CR 11 FROM
T.M. 23 TO C&A 6
SP 49-61-01 C&A 6
GARDEN III

CASH II FROM SHEET 3 OF 4 SHEETS
SP-49-61-01 S-6493 (1)

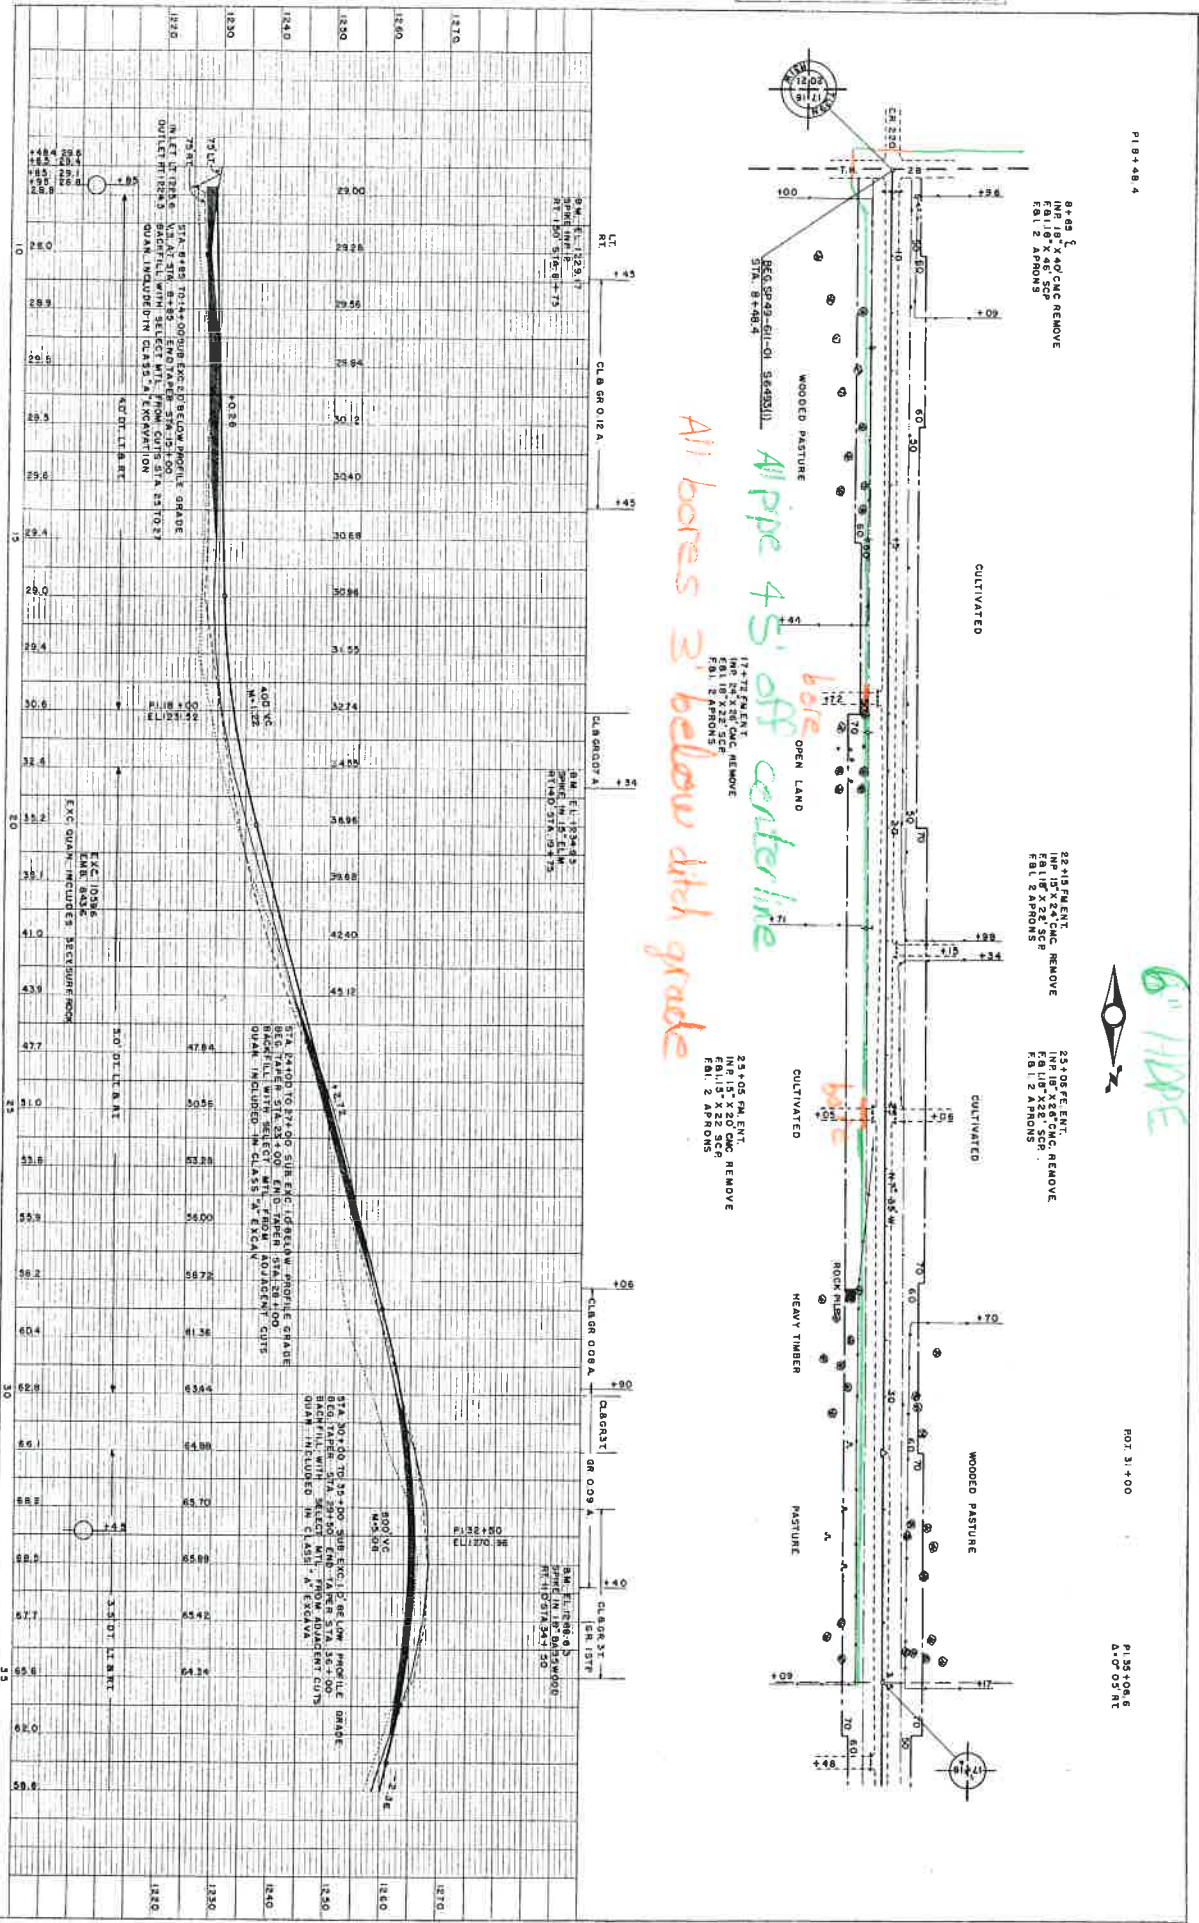
8+48.2
INF 18" X 24" CMC REMOVE
F&I 2 ASPHONS

22+15 PAVT.
INF 18" X 24" CMC REMOVE
F&I 2 ASPHONS

23+05 PAVT.
INF 18" X 24" CMC REMOVE
F&I 2 ASPHONS

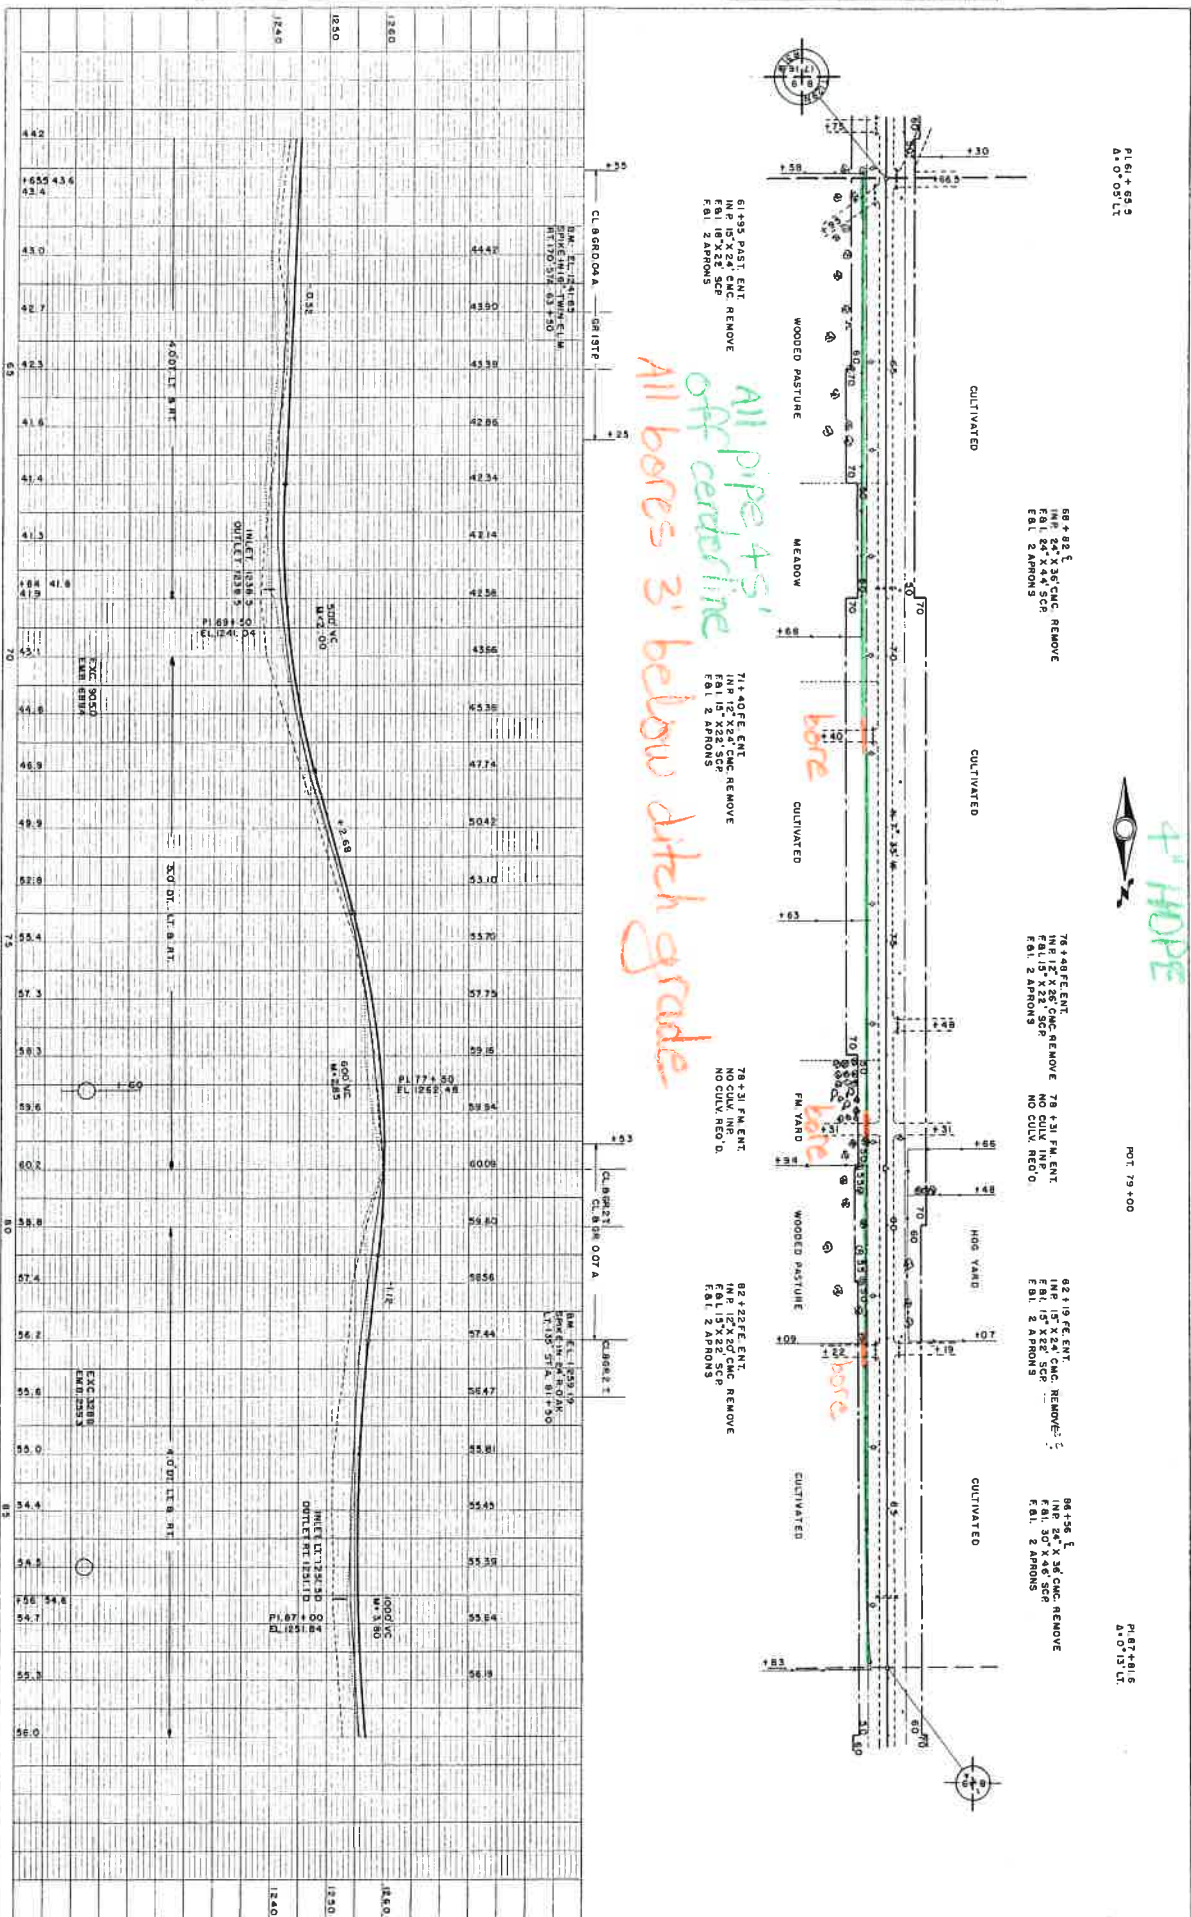
All pipe 4"
off centerline
3' below ditch grade

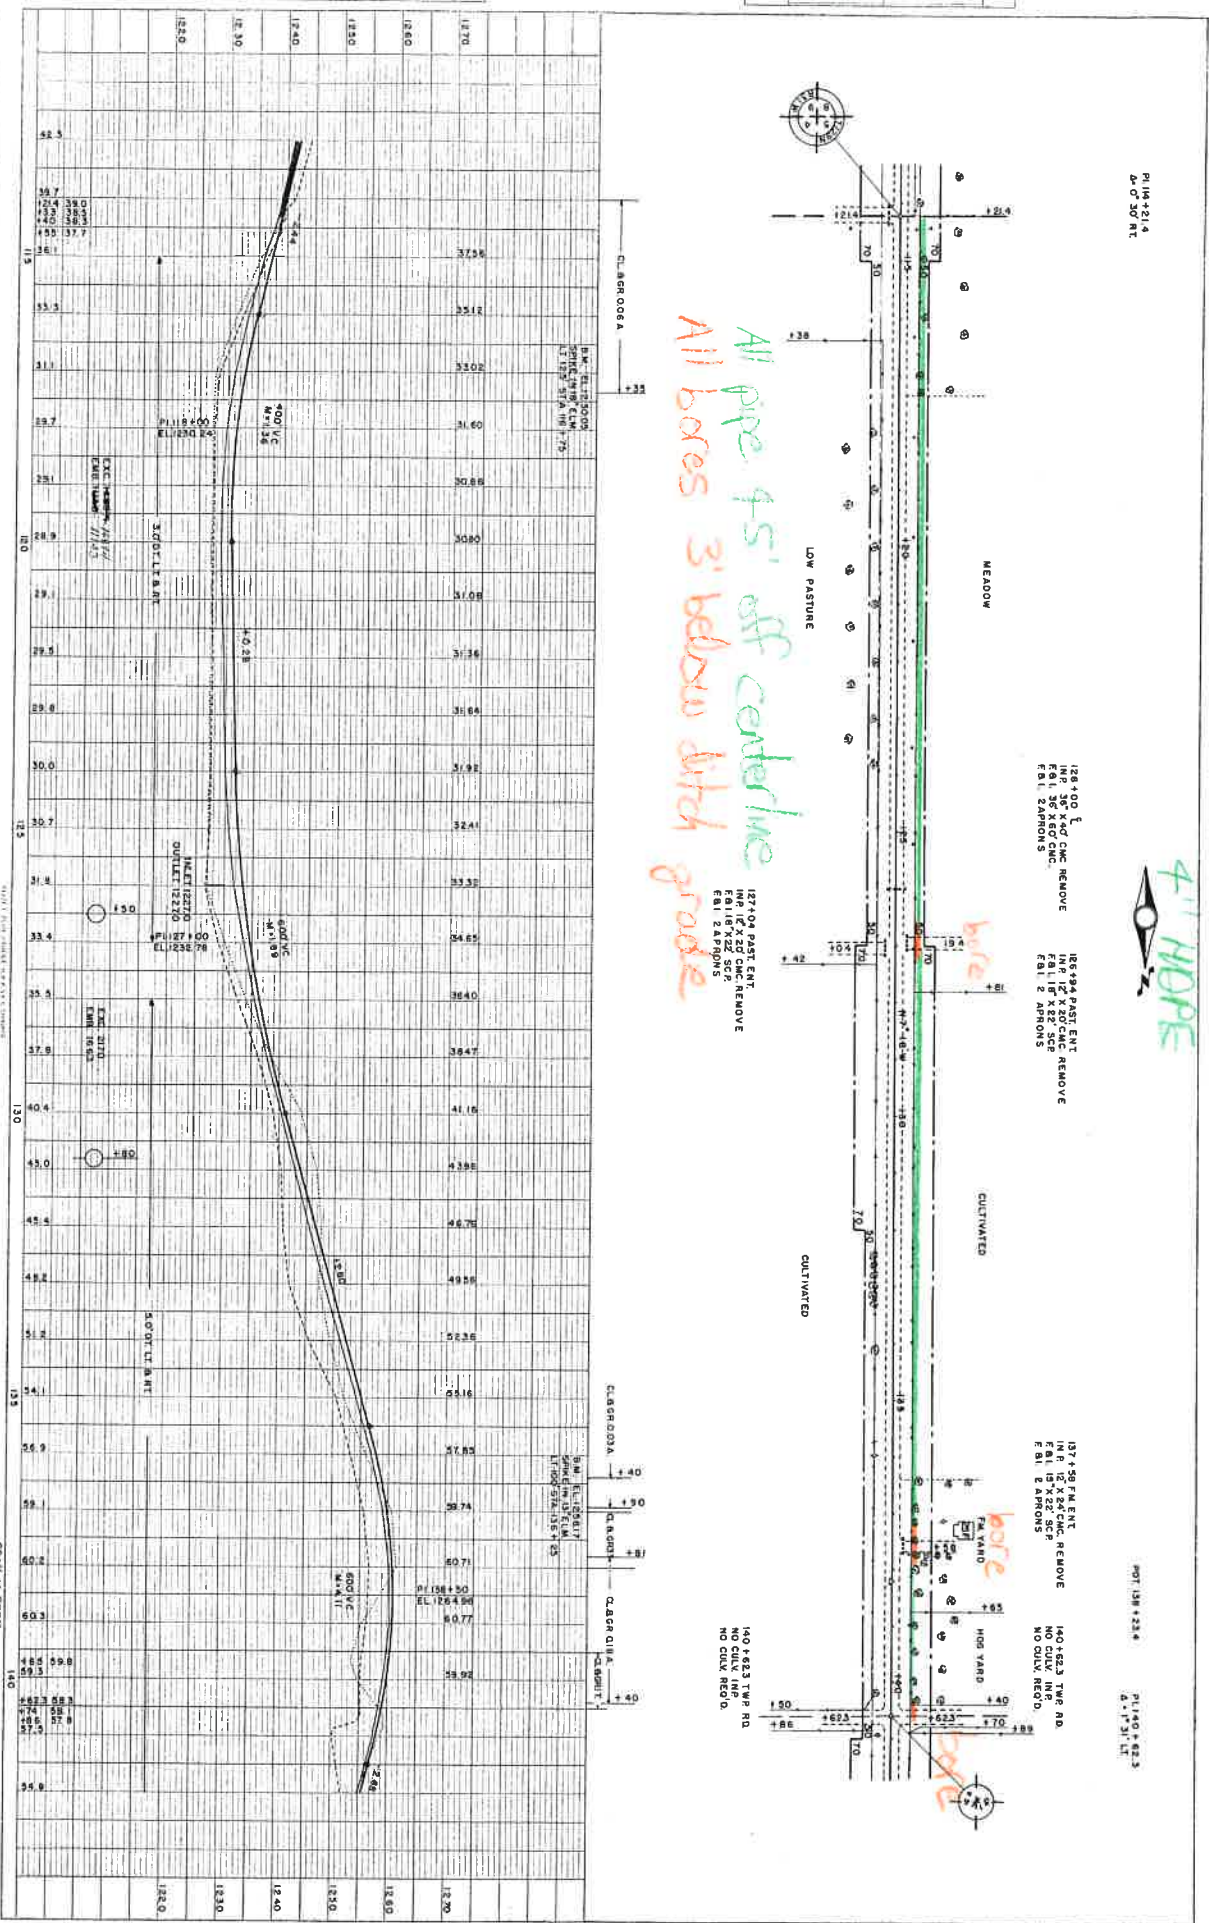
All pipe 4.5' off centerline
 All boro 3' below ditch grade

126+00 L
 INF 36" X 40" CMC REMOVE
 F&I 18" X 22" S&F
 F&I 2" ARROWS

126+94 EAST ENT
 INF 12" X 20" CMC REMOVE
 F&I 18" X 22" S&F
 F&I 2" ARROWS

127+50 FM ENT
 INF 12" X 20" CMC REMOVE
 F&I 18" X 22" S&F
 F&I 2" ARROWS

140+623 TWP RD
 NO CULV. REC'D.
